DRAFT REPORT

5th meeting of GRRF/IG on Modular Vehicle Combinations MVC

Venue: CLEPA offices
Chairman: Anders Gunneriusson (SE)
Secretariat: Pierre Teyssier/Olivier Fontaine (OICA)
Dates: 26-27 October 2015

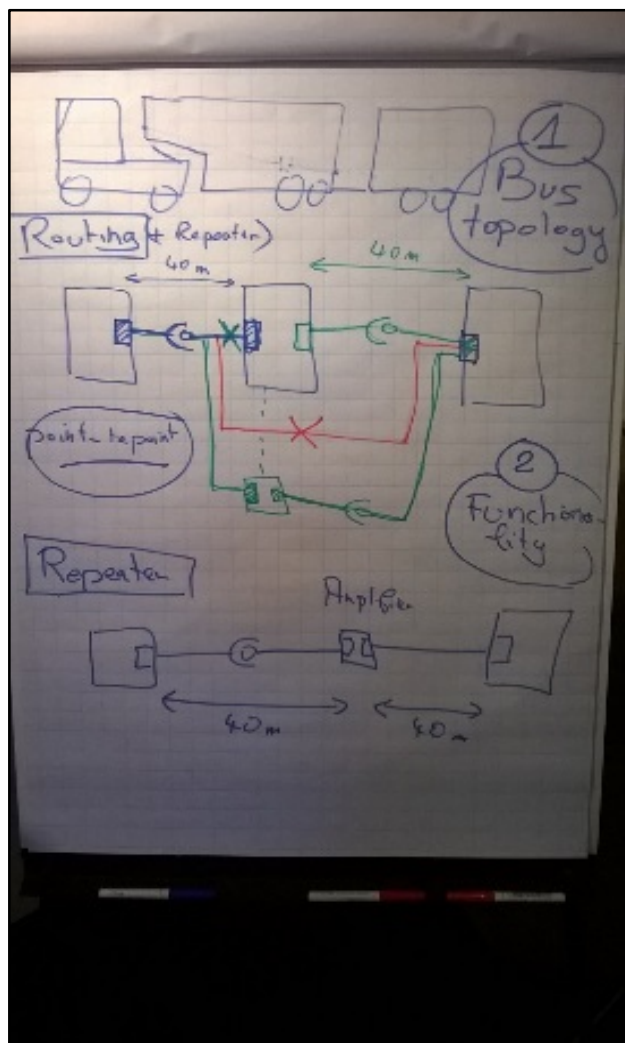
The question was raised about a combination with several trailers, each with a router, and where the 1st router would fail. Would the 2nd trailer receive the number 1?

N Norway, 18 to 80 meters are acceptable.

The question was whether there is a possibility that the text is interpreted such that a repeater is allowed, with the current texts of the regulation.
